Service Information

File In/With:	SI0285	
	New	514
Equipment Affected:	OptiView panels retrofitted on Trane, Carrier, McQuay, and YORK HT/OT High Pressure Monoshell Chillers	
OptiView Panel Microboard Replacements

FIGURE 1 - I/O FOR 031-02430-001 MICROBOARD (TRANE)

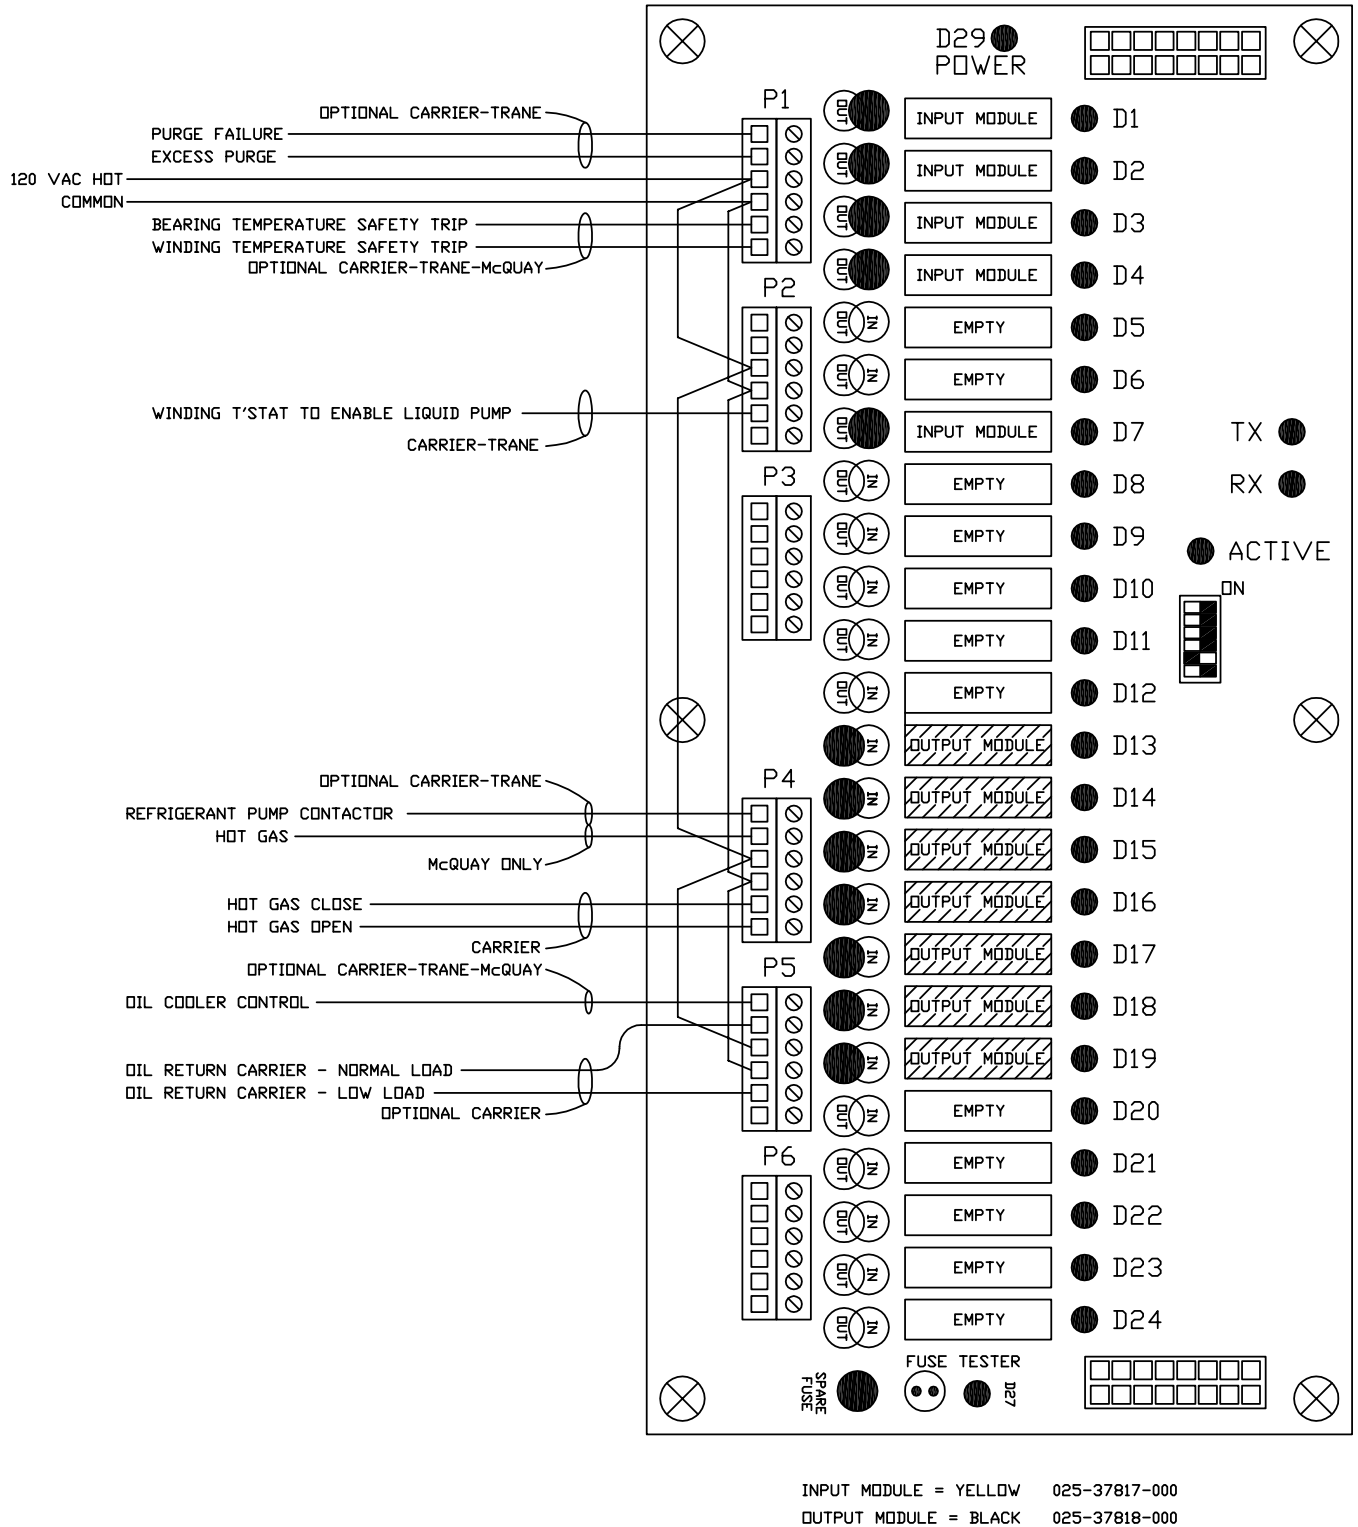
- Determine what functions are controlled by the IDC.
- Remove the IDC and label the output wires for future connection. All other wiring and relays associated with the IDC can be removed.
- The eeprom on the Frick analog board must be changed from version 1.06 to version 1.02. The Frick version 1.02 eeprom part number is 031-02535-001. This is the only change to the analog board.
- All of the yellow input relays and black output relays of the Frick digital board must be rearranged. (See the Figure 1, 2, or 3, depending upon application, for proper placement)
- All of input and output jumpers of the Frick digital board must be rearranged. (See Figure 1, 2, or 3, depending upon application, for proper placement)
- The output wires that were removed from the IDC can now be connected to the Frick digital board. (See Figure 1, 2, 3, or 4) depending upon application, for proper placement)

FIGURE 2 - DIGITAL I/O FOR 031-02430-001 MICROBOARD – 24 VOLT AC (CARRIER ONLY)

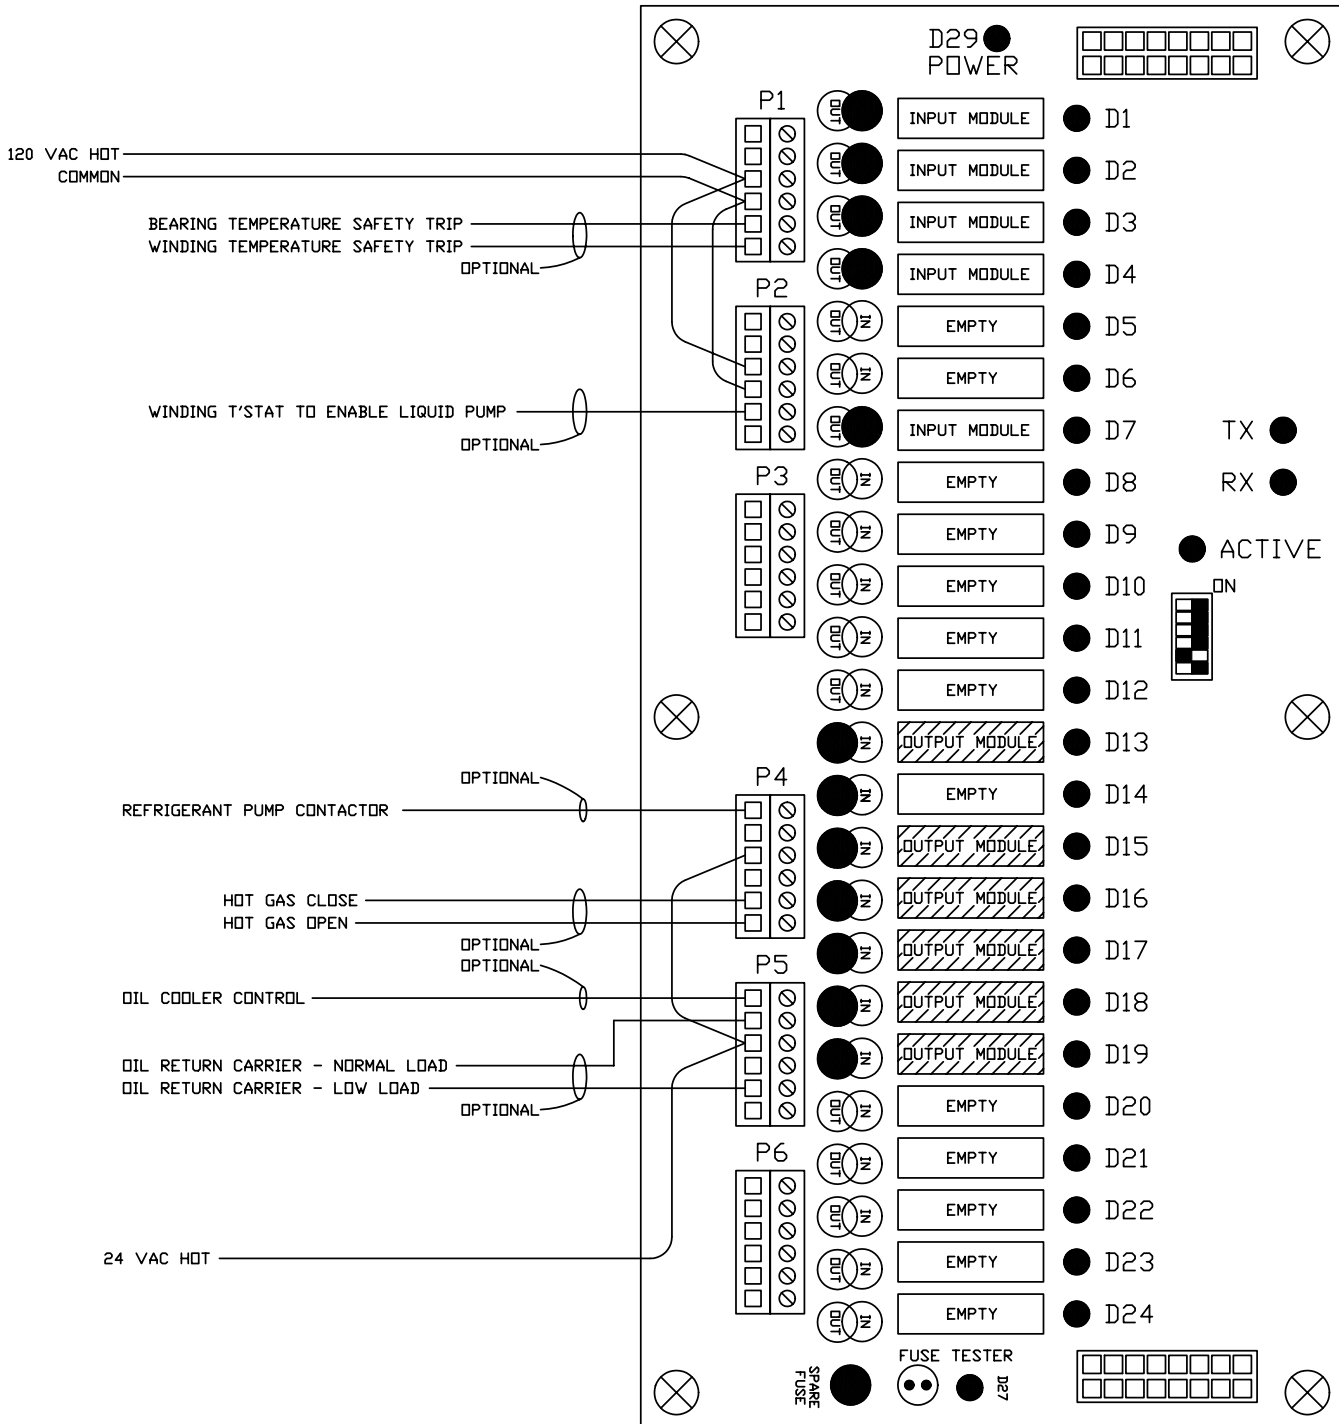
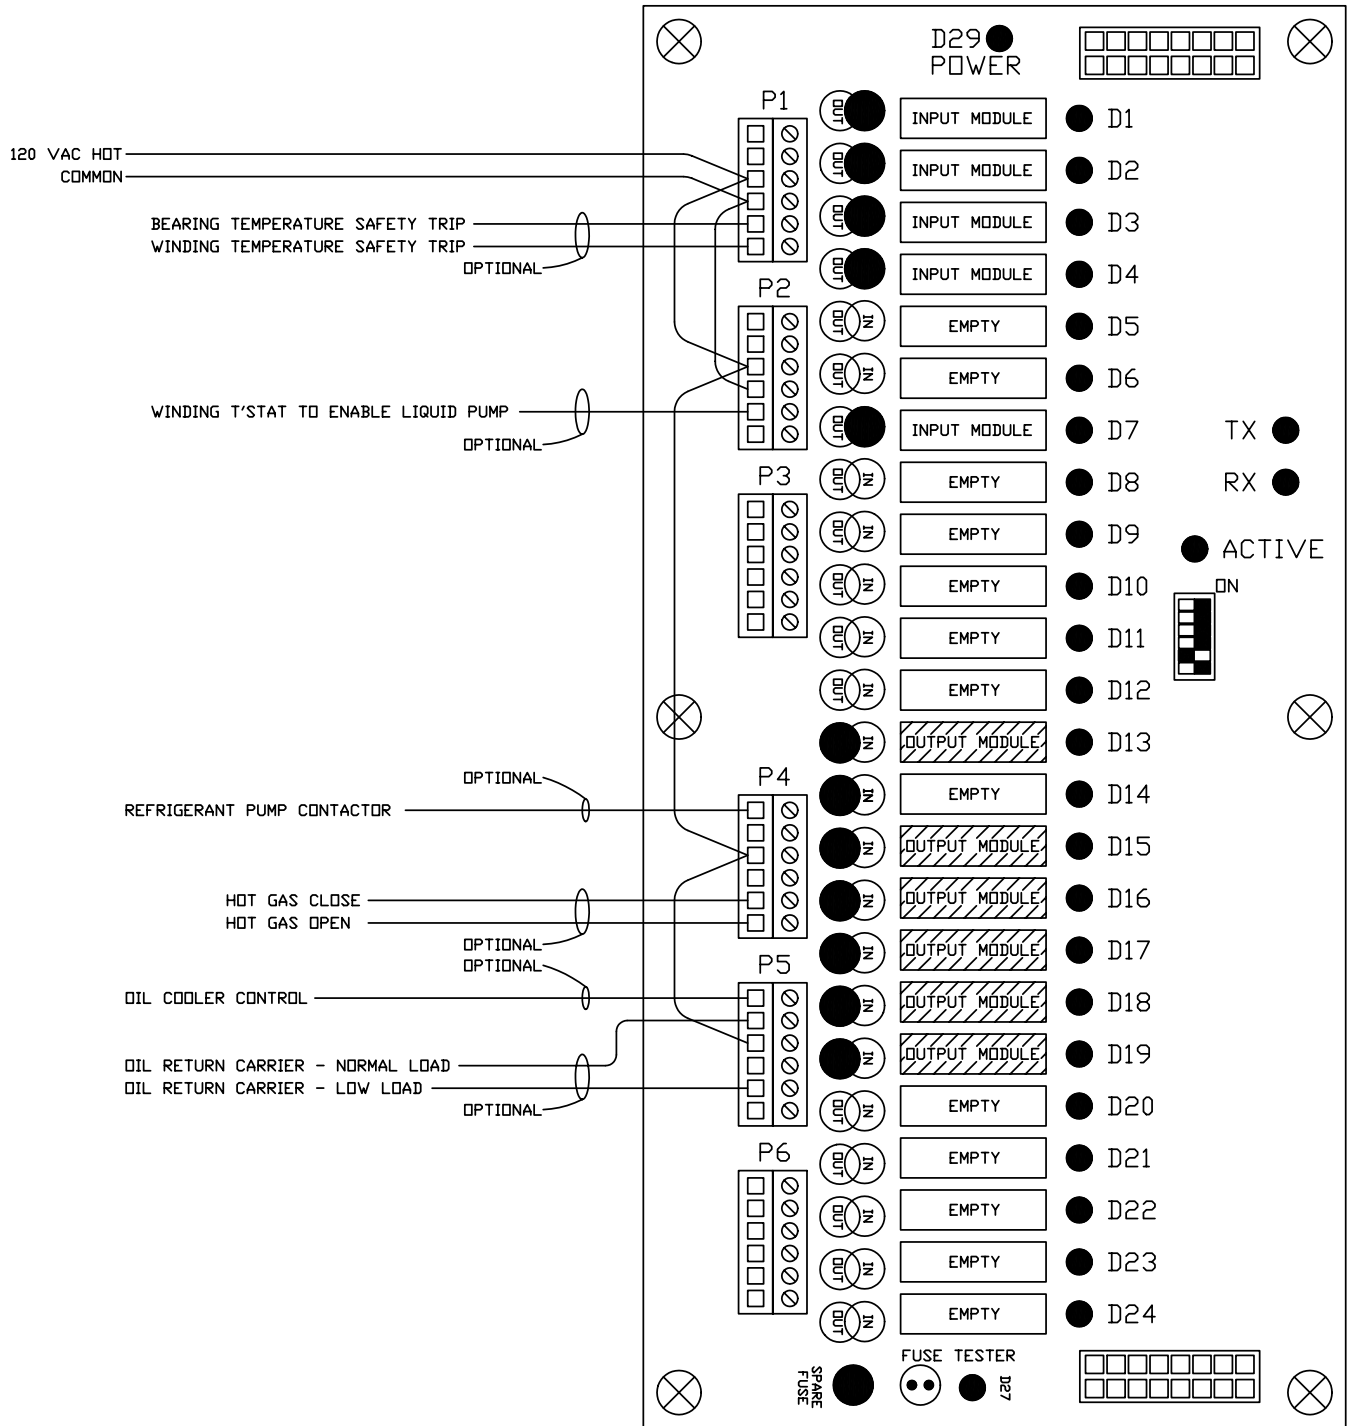
Carrier chillers can be either 24VAC or 120 VAC

FIGURE 3 - DIGITAL I/O FOR 031-02430-001 MICROBOARD – 120 AC COILS

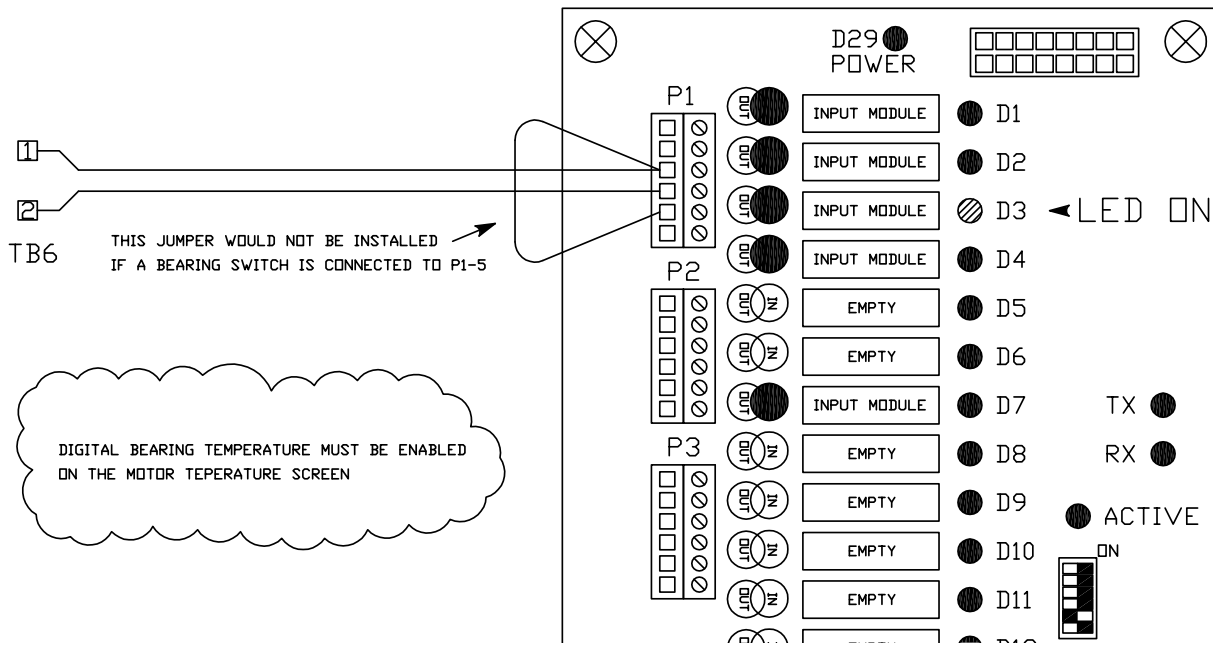
(When no digital inputs are required and a digital outpoint exists; i.e. hot gas valve, oil cooler, or refrigerant pump.)

FIGURE 4 - CONFIGURING THE DIGITAL I/O BOARD

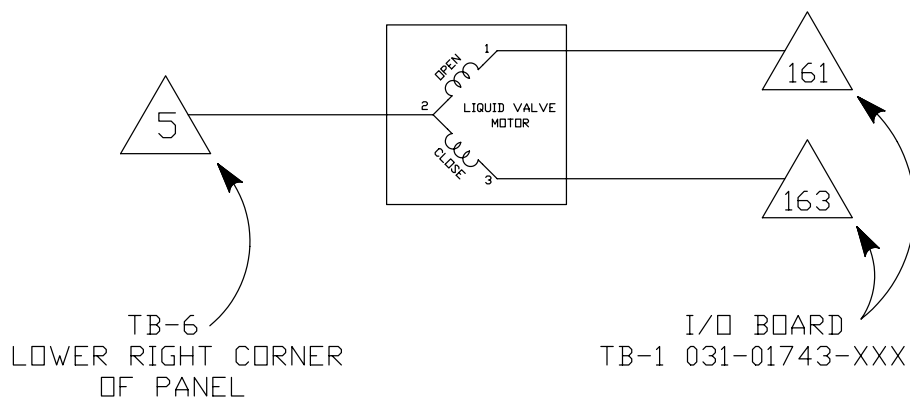
- If there are no digital inputs the digital I/O board must be configured to provide power to the output modules. See Figure 4 for jumper location. Note that digital motor bearing temperature feature must be enabled on the OptiView Motor Temperature Screen.
- If the IDC controlled the liquid by-pass control valve, the wiring will now be placed on the OptiView I/O board (031-01743-000). See Figure 5 - “Liquid Valve Control” drawing for proper placement.
